Groundwater Transfer Review Summary Form

Transfer/PA # T- 13482

GW Reviewer Jen Woody Date Review Completed: 7/24/2020

Application: T-13482

Well location map

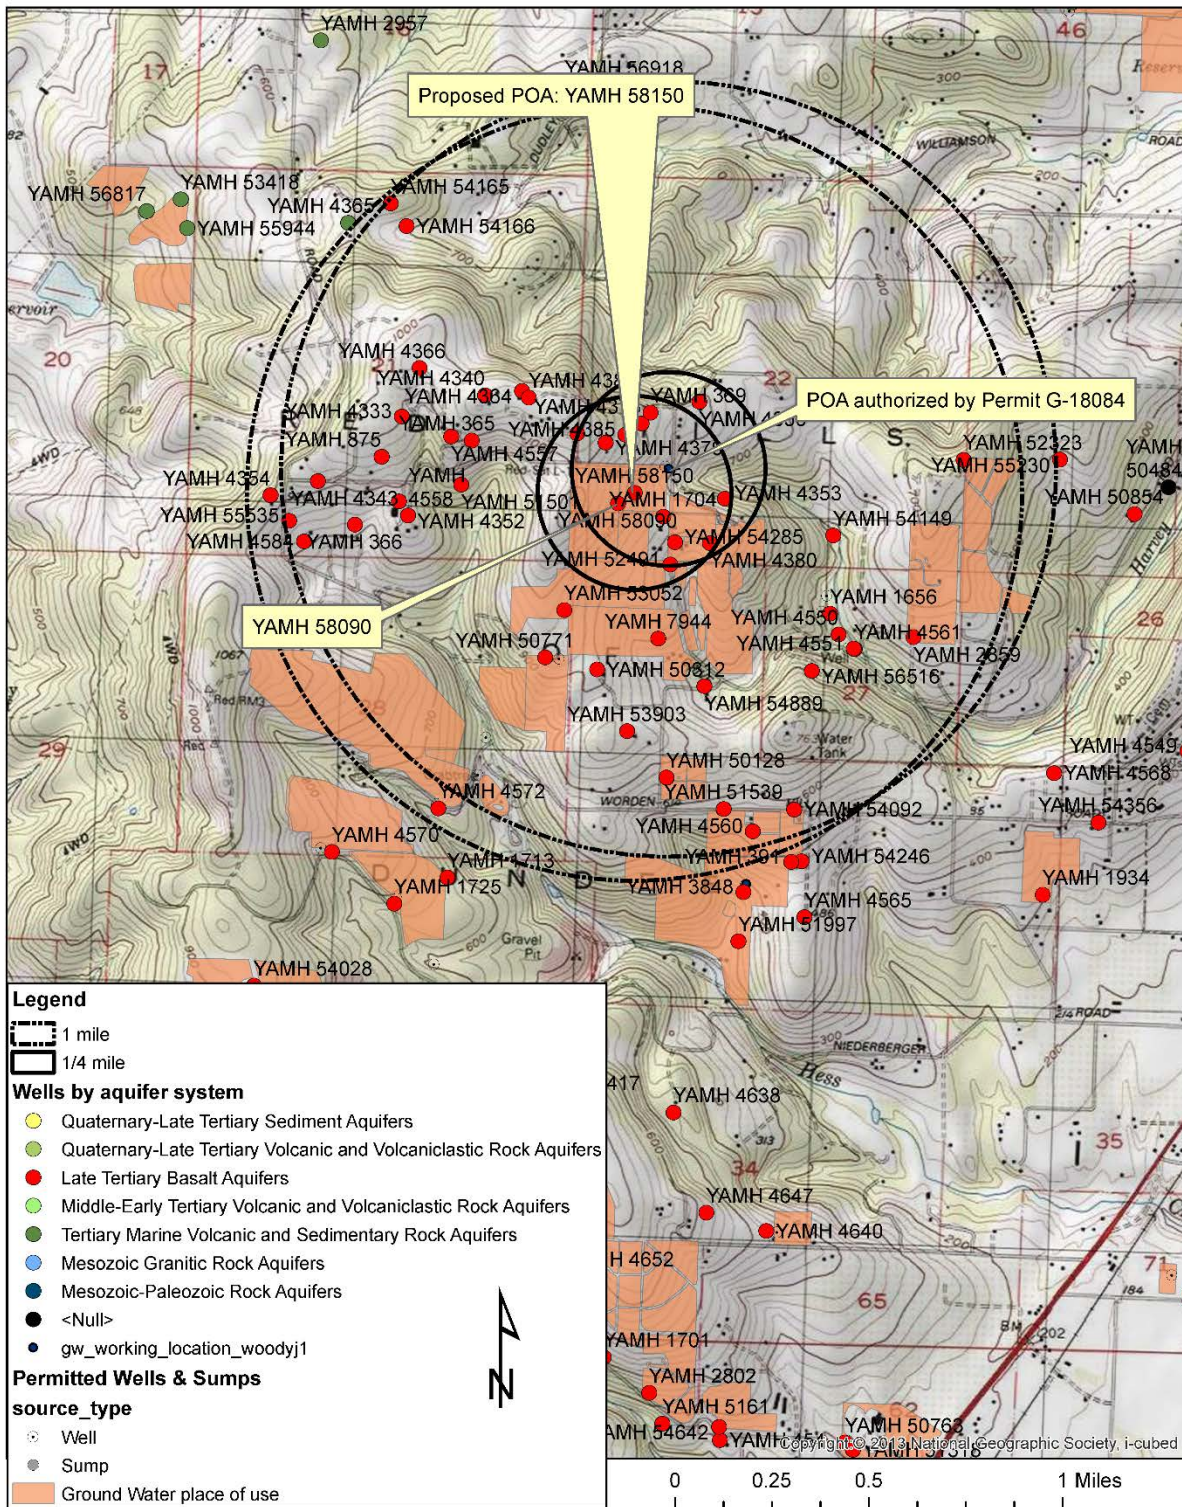
1. Basic description of the changes proposed in this transfer: T-13482 proposes to change the POA location associated with Permit G-18084 to the location where YAMH 58150 was drilled in 2019. YAMH 58150 was drilled approximately 500 feet southwest of the approved POA.

4. a) Will this proposed change, at its maximum allowed rate of use, likely result in an increase in interference with **another ground water right**?
 Yes No Comments: YAMH 58150 is located closer to YAMH 58090 (POA on application G-18501/Permit G-18116) than the approved POA. YAMH 58150 and YAMH 58090 are approximately 300 feet apart.

Distance drawdown estimates

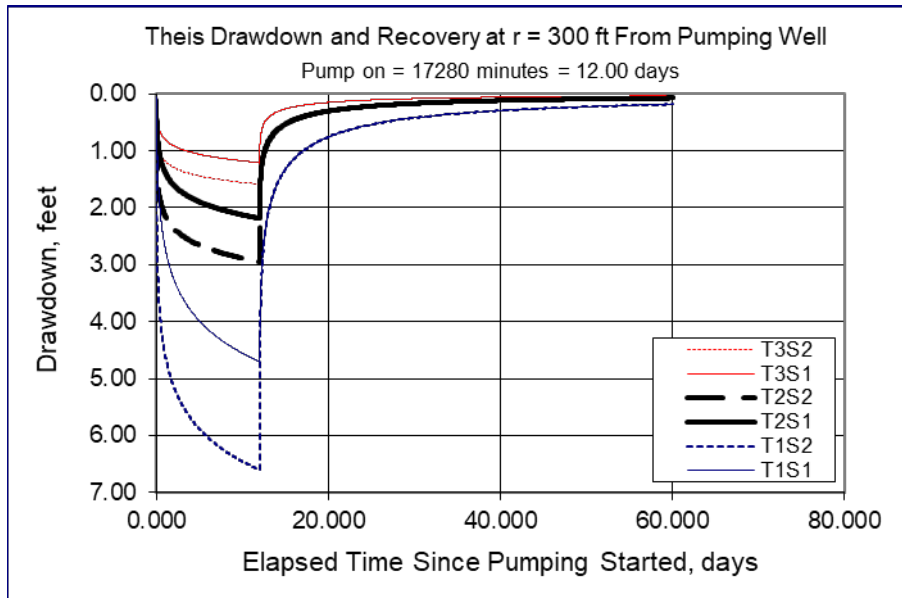
Yes No If yes, explain: Assuming YAMH 58150 pumped at the maximum allowed rate (0.12 cfs/53 gpm), the total annual duty on 7 acres of irrigation would be met in approximately 12 days. Distance drawdown estimates of this worst-case scenario indicate 1 to 6.5 feet if drawdown at YAMH 58090. Given the available head at the well, this degree of interference is not expected to prevent access to the water YAMH 58090 is legally entitled.
